## **Addendum No. 2**

### **BRAVO AVENUE INTERTIE PROJECT**

PWP Bid No. WA-2014-113  
March 11, 2014

SHEET NUMBER **D1**

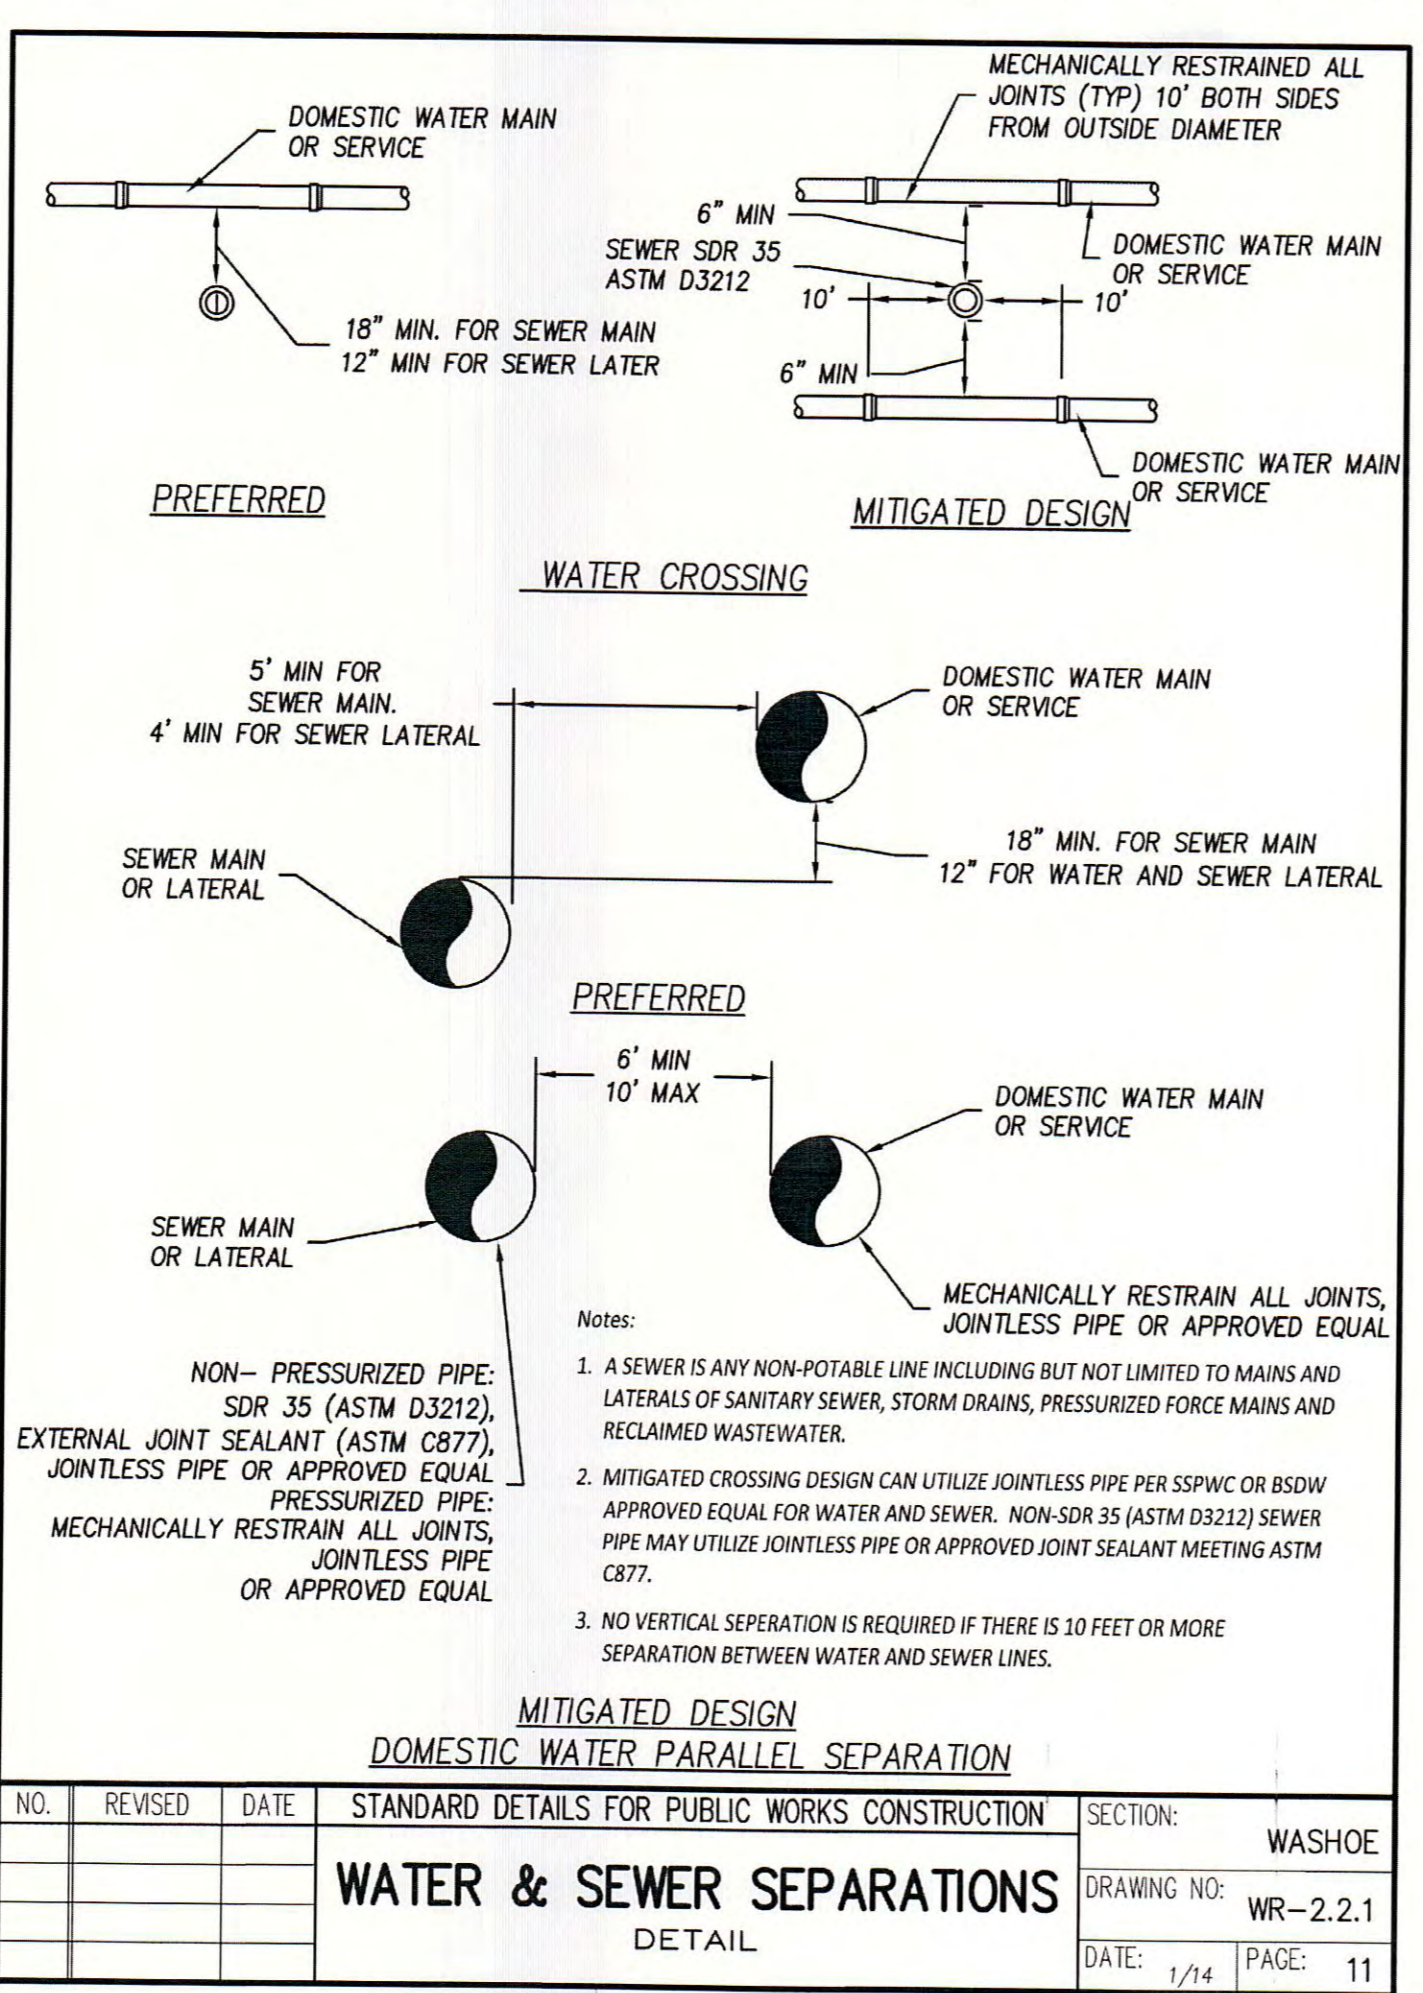
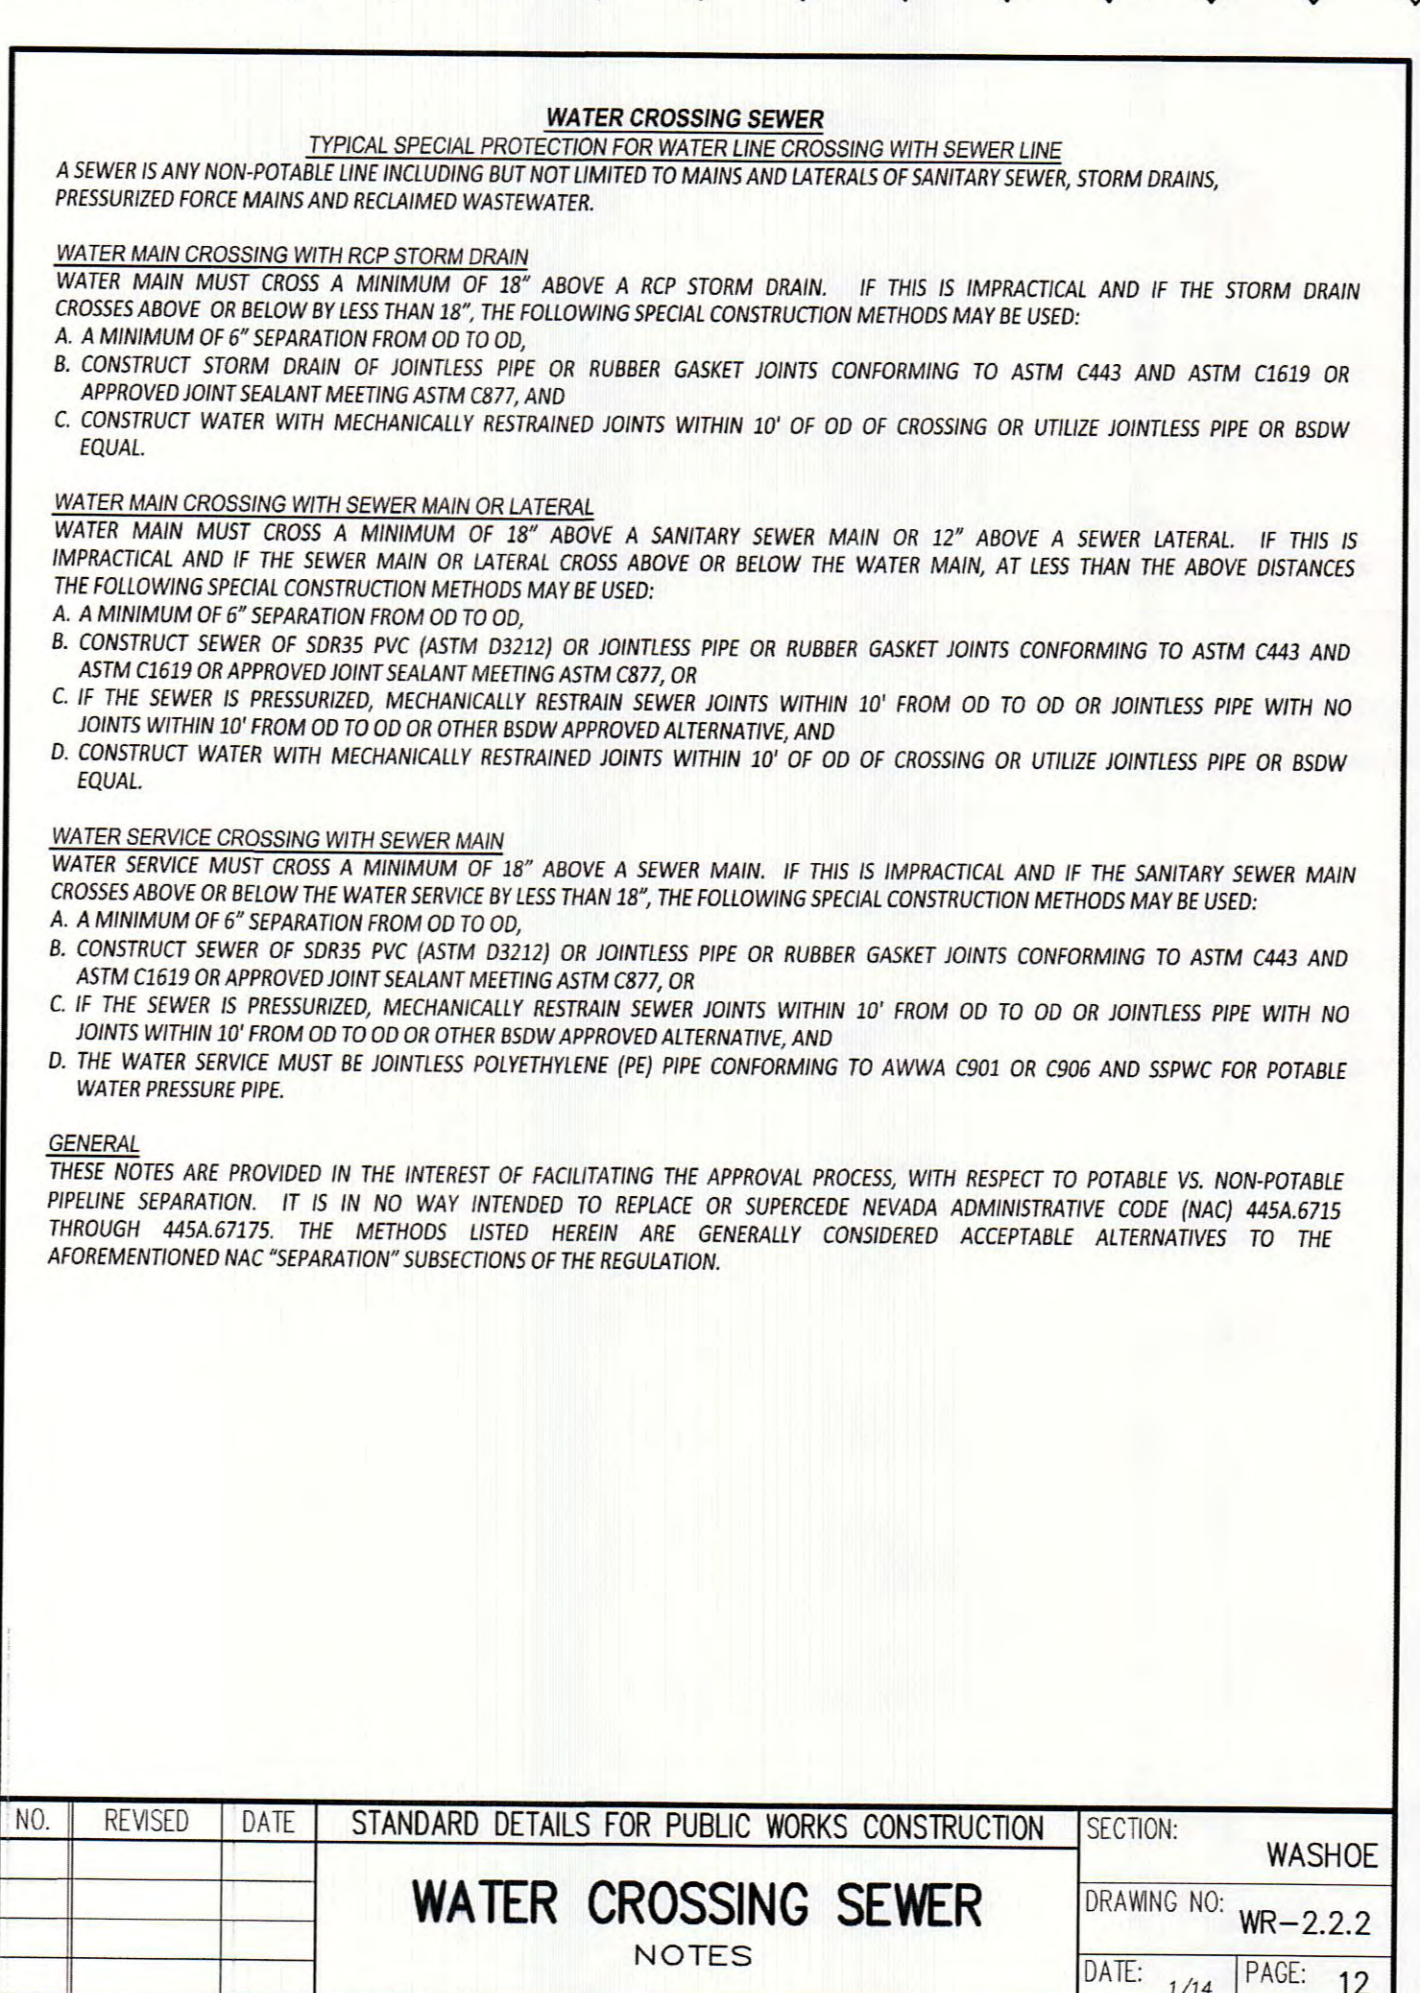
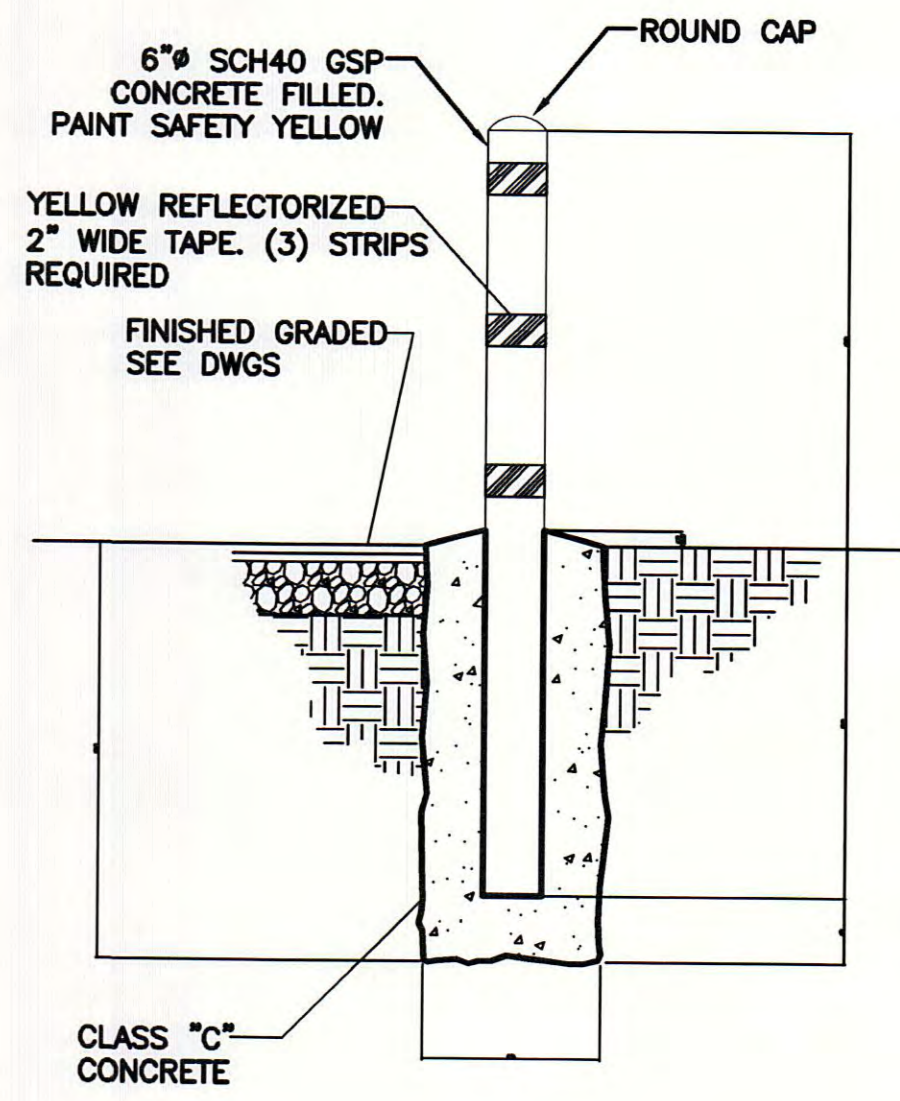
**Clarification Item 3:** Reference revised Sheet D1 – Details A/D1, B/D1, and C/D1 have been replaced in their entirety with recently updated Public Works Standard details.

SHEET NUMBER  
**D3**  
15 OF 29

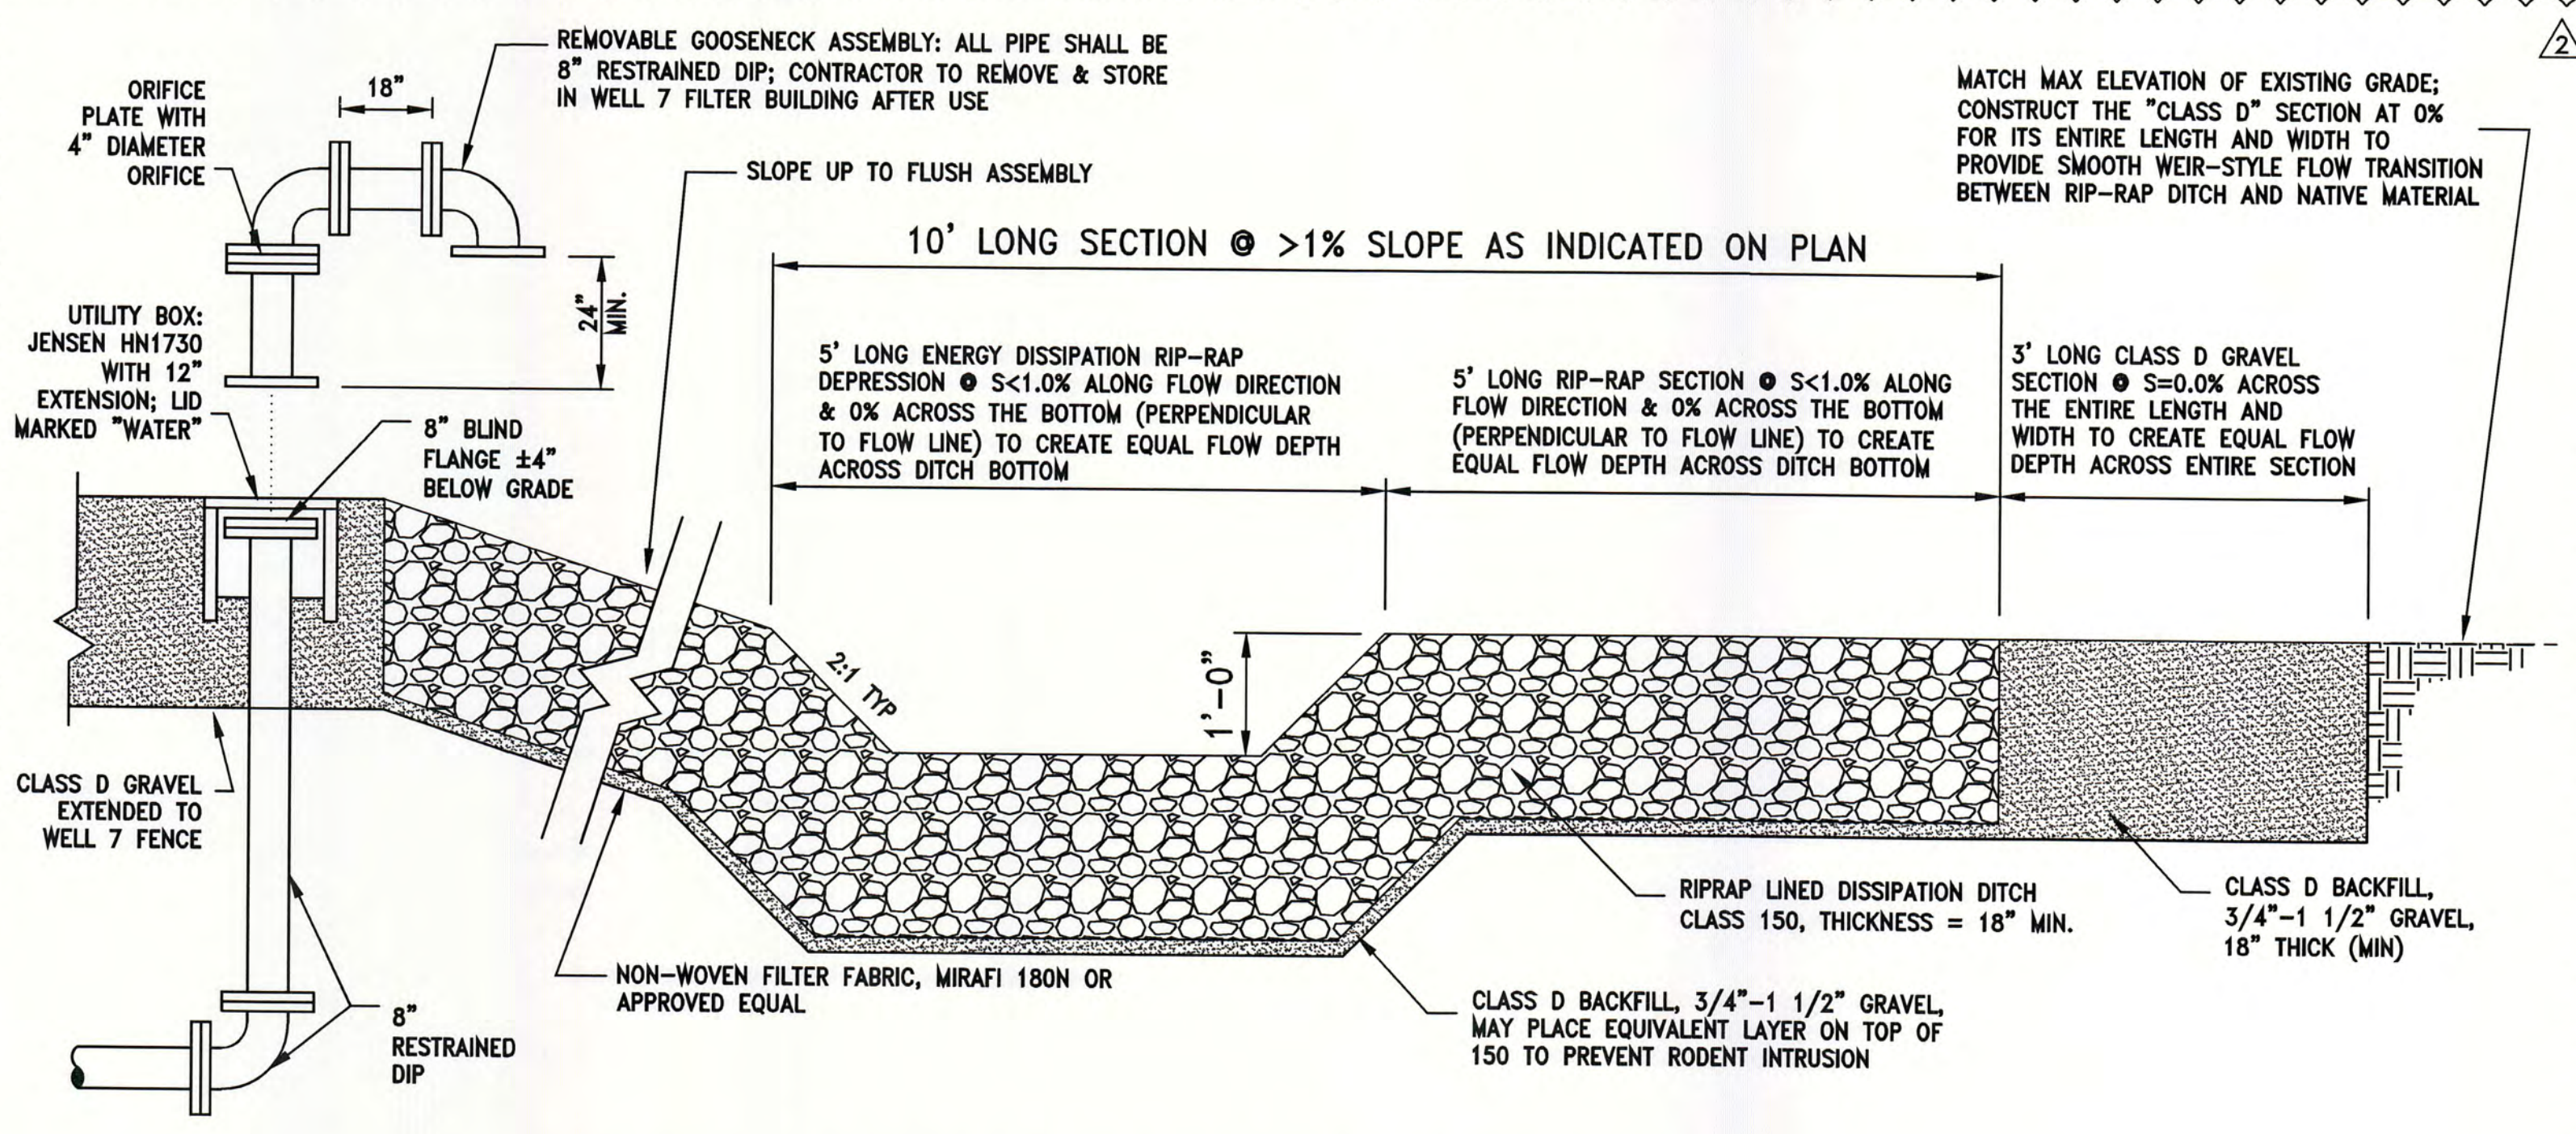
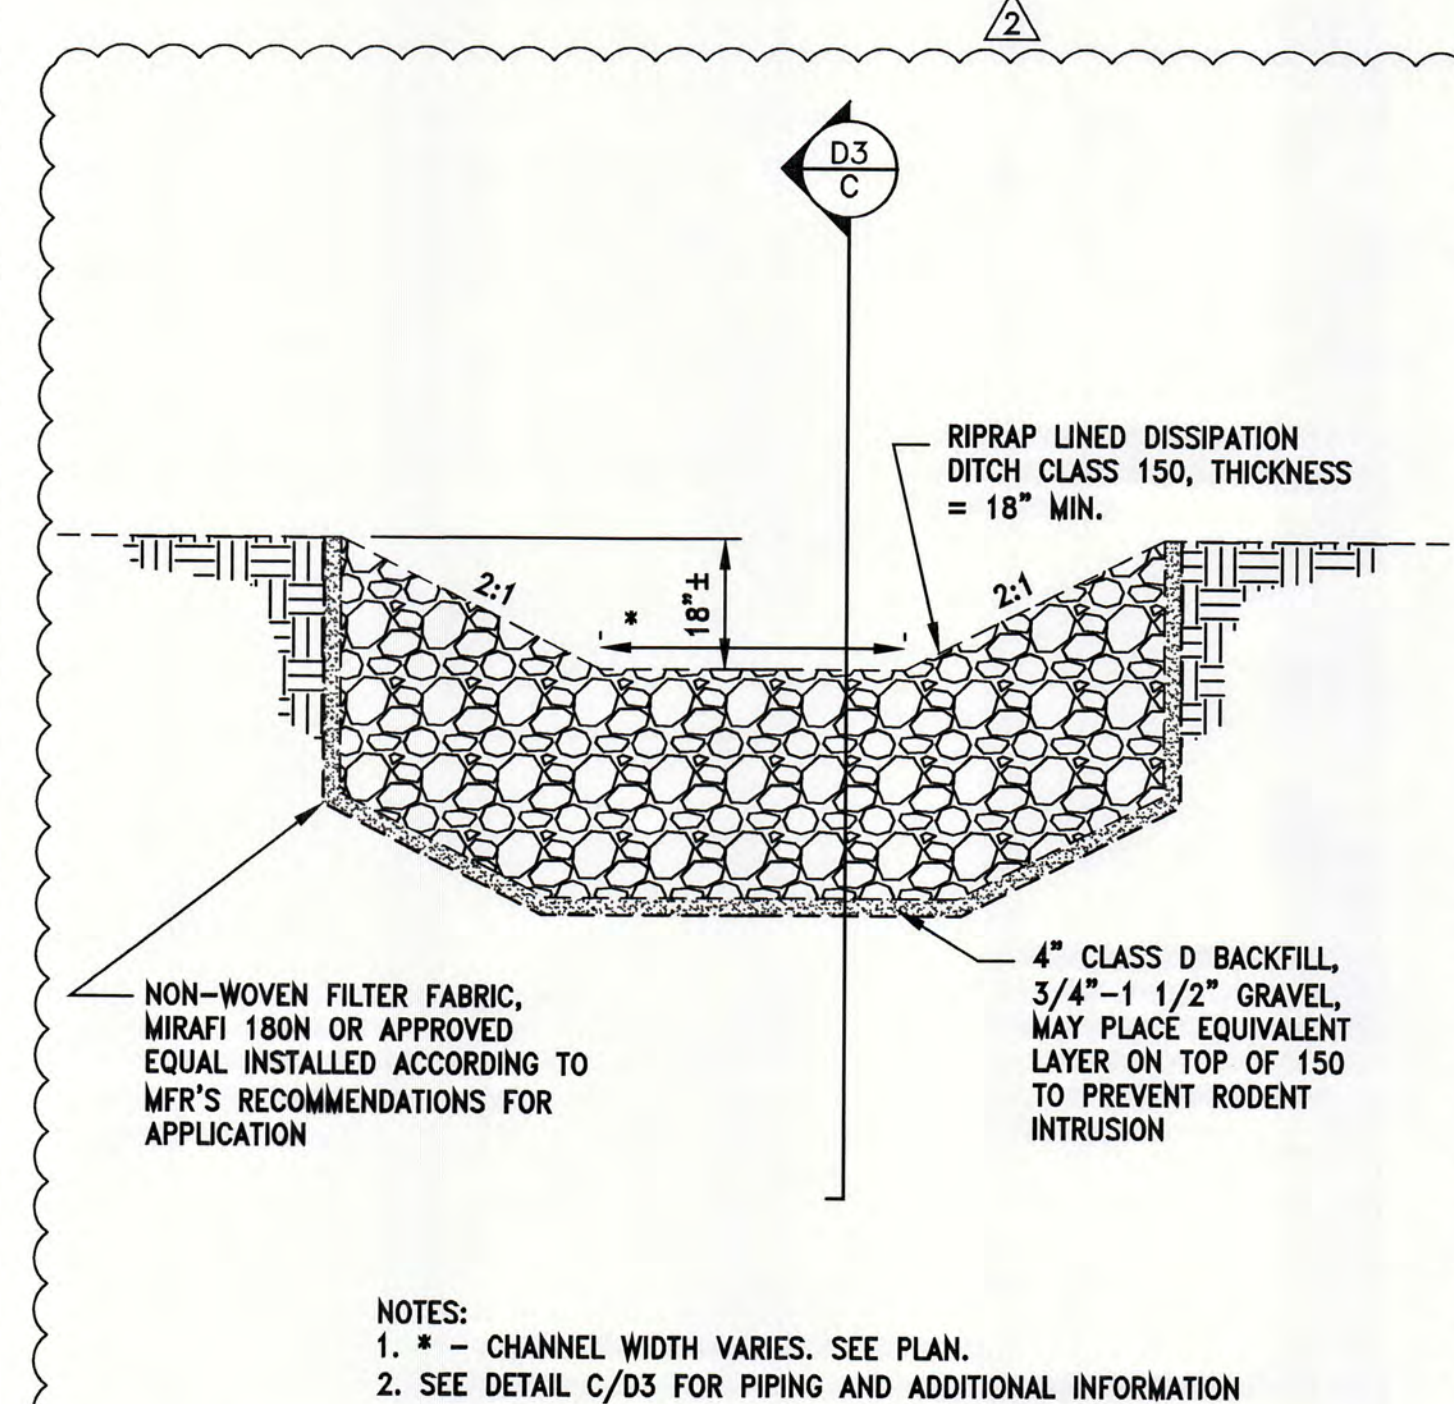
**Clarification Item 4:** Reference revised Sheet D3 – Details C/D3 and D/D3 have been replaced in their entirety.
